# Access Compliance Report

## Public Rights-of-Way

Intersection ID: 2509	Main Street: LYNNEWOOD_GLEN_DR	Cross Street: WHITEGATE_LN	Location:	N
ADA ID: 0F7E97DB2076	Ramp Type: Perp	Initial Pass/Fail: Fail	Overall Compliance: No	Severity Score: 12.5
Codes/Mitigation Info/Possible Solution		Field Measurements/Component Compliance

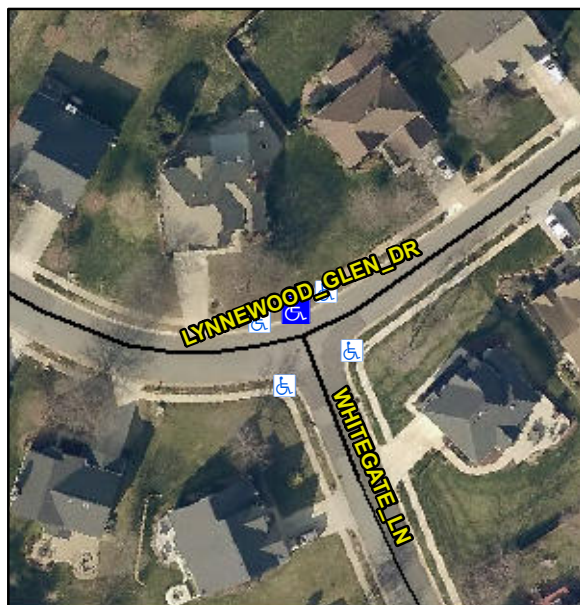
**Not Found, R304.2.2**

Compliance	Description	Data	Compliance	Description	Data
N/A	Ramp Length (in)	48.0	No	Ramp Slope (%)	11.3
Yes	Ramp Width (in)	60.0	Yes	Ramp XSlope (%)	0.2
N/A	Flare Type LT	N/A	N/A	Flare Type RT	N/A
N/A	Flare Slope LT (%)	N/A	N/A	Flare Slope RT (%)	N/A
N/A	Flare Traversable LT?	N/A	N/A	Flare Traversable RT?	N/A
N/A	Landing Length (in)	N/A	N/A	DWS Provided?	N/A
N/A	Landing Width (in)	N/A	N/A	DWS Contrast?	N/A
N/A	Landing Slope (%)	N/A	N/A	DWS Length (in)	N/A
N/A	Landing X Slope (%)	N/A	N/A	DWS Full Width?	N/A
N/A	Landing Curb? (Y/N)	N/A	N/A	DWS Offset (in)	N/A
N/A	Shared Landing?	N/A			
N/A	Gutter Ponding?	N/A	N/A	Gutter Slope (%)	N/A
N/A	Gutter Lip Ht (in)	N/A	N/A	Gutter X Slope (%)	N/A
N/A	Painted X Walk1?	No	N/A	Painted X Walk2?	N/A
	X Walk 1 Direction	To S		X Walk 2 Direction	N/A
N/A	X Walk 1 Width (in)	N/A	N/A	X Walk 2 Width (in)	N/A
	X Walk 1 Slope (%)	0.7		X Walk 2 Slope (%)	N/A
	X Walk 1 X Slope (%)	1.1		X Walk 2 X Slope (%)	N/A

**Remove & Replace Entire Ramp.**
